## SERVICE BULLETIN No PA SB0901

**SUBJECT:** 3-RING RISER INSPECTION

**IDENTIFICATION:** All 3-ring risers manufactured by Parachutes Australia

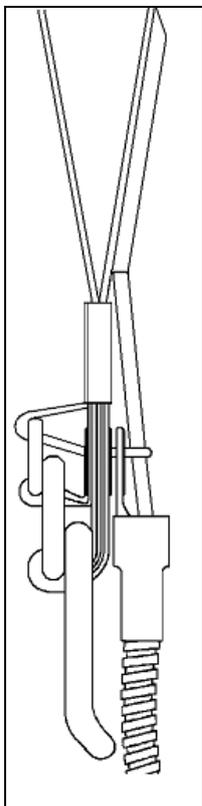
Older versions of PA 3-ring risers have a shorter loop than now in common use. All 3-ring risers manufactured by PA can remain in service provided they meet the following requirements as extracted from the APF Service Bulletin APF010801-C

- The rings should overlap each other and maintain metal to metal contact between each other.
- The rings should be aligned in parallel planes.
- The smallest ring should not be pulled snug against the grommet by the locking loop which should be long enough to give it some play.
- The locking loop should go straight through the riser grommet on its way to the cable housing end fitting.
- It should be checked that NO suspended load is supported by the cable housing and locking loop due to the cable housing being incorrectly positioned in the harness or being too short.

PA manufactured 3- ring risers **not** meeting the requirements of APF Service Bulletin APF010801-C must be sent to PA for correction and return at no charge.

The owners of PA manufactured 3- ring risers that have locking loops shorter than that as detailed in the above mentioned Safety Notice but **do** meet the requirements of APF Service Bulletin APF010801-C that feel uncomfortable about the length of the locking loops can also send them to PA for lengthening and be returned at no charge.
